Staff Report

Infill Housing Design Review Committee

File Number: 3-J-22-IH

Location: 3419 Gap Rd. **Parcel ID** 81 I T 009
Zoning: RN-2 (Single-Family Residential Neighborhood)
District: Lonsdale Infill Housing Overlay District

Drawn: MSG
 ARCHITECTURAL SITE PLAN

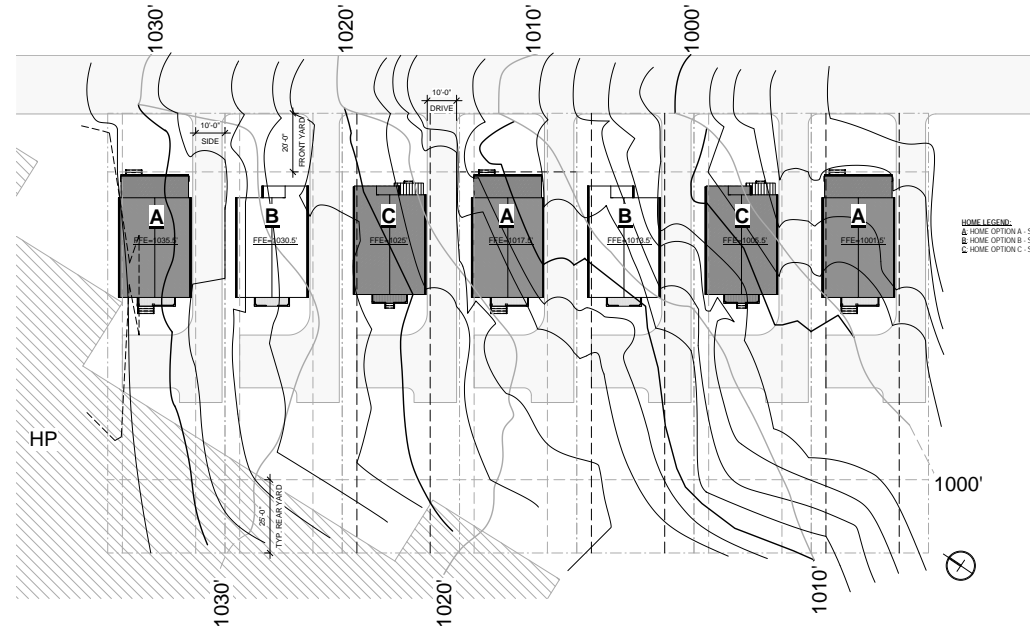
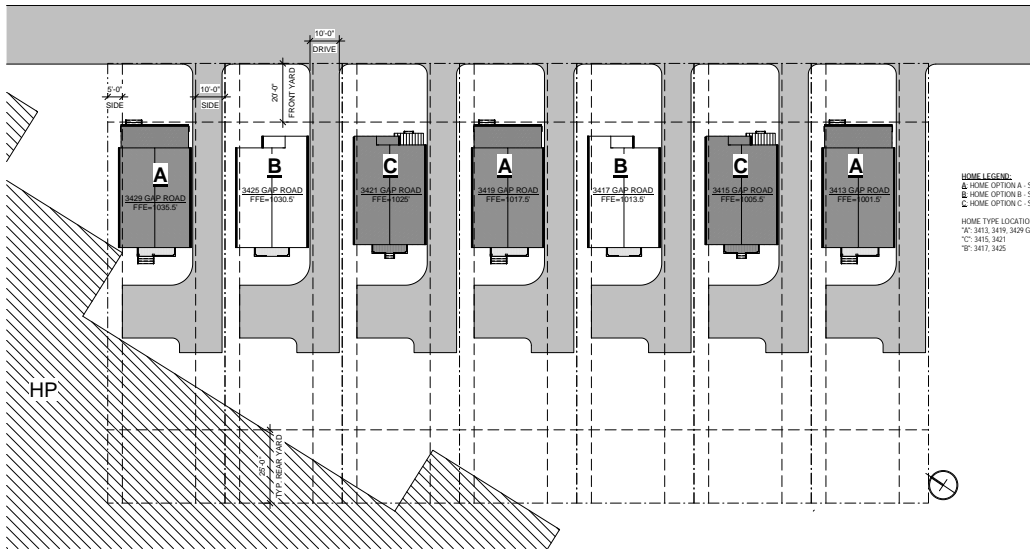
1. The proposed front setback is 28' from the front property line, with the front porch at 20' from the front property line. There are only three other houses on the block. 3401 Gap Road is located 42' from the front property line, and the new construction houses at 3405 and 3409 Gap Road are also set 42' from the front property line. The subject property is one of seven new houses to be constructed on the block, so the front setbacks will effectively create a new street pattern. The submitted site plans do not specifically call out the front setback measurement. Overall, the proposed front setbacks should be confirmed to create consistent front yard spaces along the block.

The seven adjacent new houses will demonstrate consistent side yard setbacks while accommodating the necessary side driveways. The applicant should confirm the left side exterior walls of all 7 houses will stay within the 5' side setback required allow windows on side elevation walls.

3. There is no operable alley on the block. The proposed parking meets Infill Housing design guidelines by limiting access to one lane between the street and the façade, and the design benefits from the parking pads being placed behind the house. As proposed, the site plans meet City Engineering standards, but any modifications in permitting should meet Engineering standards and Infill Housing design guidelines.

- 1) Front setback should be confirmed to create consistent front yard space along the block, with approval of final site plans by staff;
- 2) Left side setback to be a minimum of 5', so the left side elevations can retain windows;
- 3) Final site plan to meet City Engineering standards and Infill Housing design guidelines;
- 4) Add one bay of windows on the left side elevation, with approval by staff;
- 5) Final site plan to show one tree in front and one tree in rear yard.

Drawn: MSG
HOME OPTION A -
EXTERIOR
ELEVATIONS

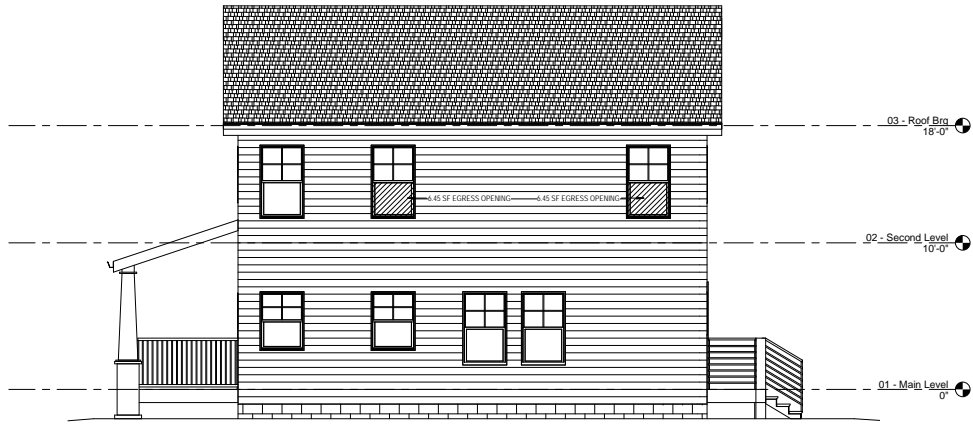
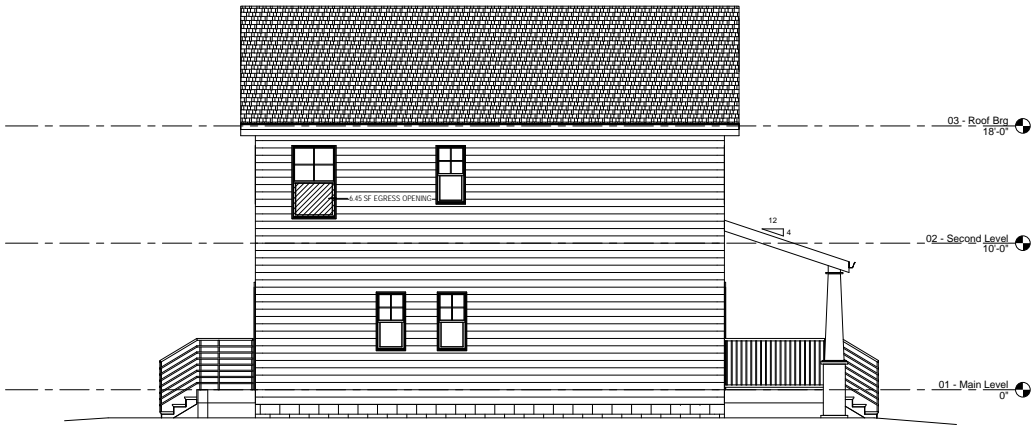
4. The proposed front elevation is similar in scale to other houses along the street, especially the adjacent infill construction. The 22' wide, three-bay façade is comparable to historic houses' façade widths. The porch roof contributes additional roofline complexity. The applicant should provide foundation heights for the proposed houses.

5. Design A includes a full-length, shed-roof porch supported by Craftsman-style tapered posts on piers. The 8' deep porch meets the design guidelines and uses "posts and railings like those used in the historic era of the neighborhood's development."

6. Guidelines note that "window and door styles should be similar to original or historic houses" in the surrounding context. 1/1 windows instead of the proposed 4/1 would be more appropriate for the surrounding context. While the façade shows "similar proportion and position as original houses on the block," the side elevations show multiple sizes of windows with somewhat irregular placement. The left side elevation would benefit from an additional bay of windows closer to the façade, as the large swath of wall with no transparency will be significantly visible from the street.

7. At 8/12, the roof has a similar pitch to original houses in the neighborhood. The 4/12 pitch, shed roof will be somewhat shallow in proportion to the rest of the house.
